Report for Selwyn District Council

Peer Review of PDP Glint and Glare Assessment for Solar Farm at 80 Struie Road Hororata

Date: 15 January 2025

Velden Aviation Consulting Ltd

Figure 3.1 Inconsistency in proposed site layout between PDP AEE submitted report and Glint and Glare Assessment Report

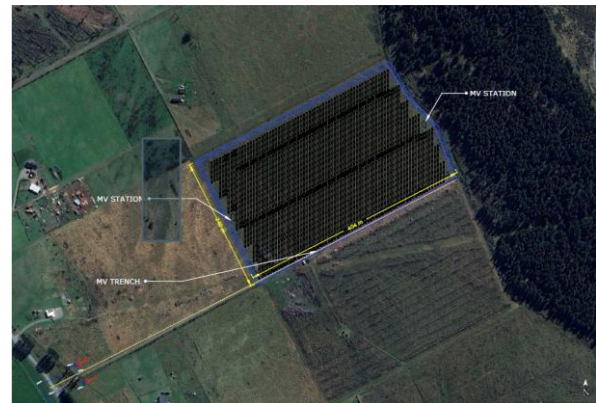
The Photovoltaic array layout being considered as per PDP Glint and Glare Assessment Report and what is shown in the AEE report and actual plans of the site appear to be inconsistent as illustrated in Figure 3.1 below.

It should be noted that although there is inconsistency in the proposed layout area, the PDP glint and glare assessment still contains the area of the AEE report and submitted plan but also includes an additional area adjacent to this as shown in Figure 3.1 (a) above. The combined area is noted as PV1, and any results of the PDP may therefore potentially be for the additional area which this peer review assessment has included as PV2.

Figure 3.2 PDP Report PV1 Array , VACL peer review report showing this as PV1 and PV2 arrays

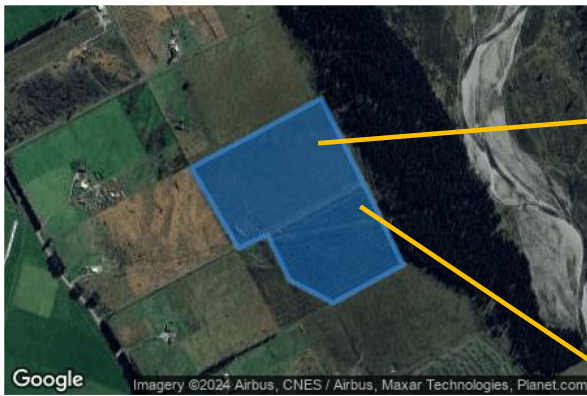
The PV1 array area of this VACL peer review assessment is more aligned with the footprint as shown in the PDP AEE report site layout and as per PV site Array Plans (in Appendix B of AEE report) to ensure greater accuracy of the assessment.

The PV2 Array is added so that both the PV1 And PV2 arrays in this peer review assessment can be compared better with the PDP glare assessment which shows these areas combined.

Figure 3.2.1 Location of houses and dwellings considered by PDP for Glint and Glare Assessment

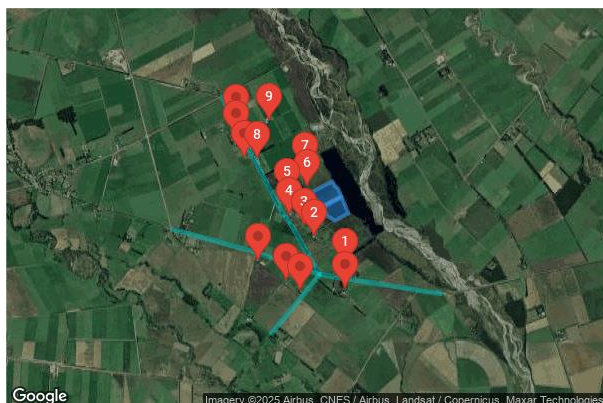
It was noted that the PDP report only considered seven nearest dwellings on the basis of line of sight to the solar panels. They also used observer eye heights for discrete receptors of no greater than 1.5m for the dwellings and did not elaborate if these were single or two storey dwellings.

PDP glare report states that ‘it is likely that in many cases windbreak hedges and other objects may obscure all of the view of the panels’.

The peer reviewer agrees that this is normally the case however the ForgeSolar software does not take these into account and assumes a clear and flat earth free of obstructions. Unless the results show no adverse impact then local obstructions and or vegetation would then need to be modelled appropriately.

Normal observer height is taken as 1.8m taking into account dwelling foundations and a sitting resident. No other receptor heights have been taken into account for any buildings or dwellings where observer heights may be higher than the 1.8m where normally for 2 storey dwellings this is taken as 3.6m .

While VACL agrees with the dwellings chosen by PDP, it is considered that further dwellings also need to be taken into account that fall within a 1km radius from the Struie road solar farm. These further dwellings are shown in the below diagram Figure 3.2.2 and associated table.
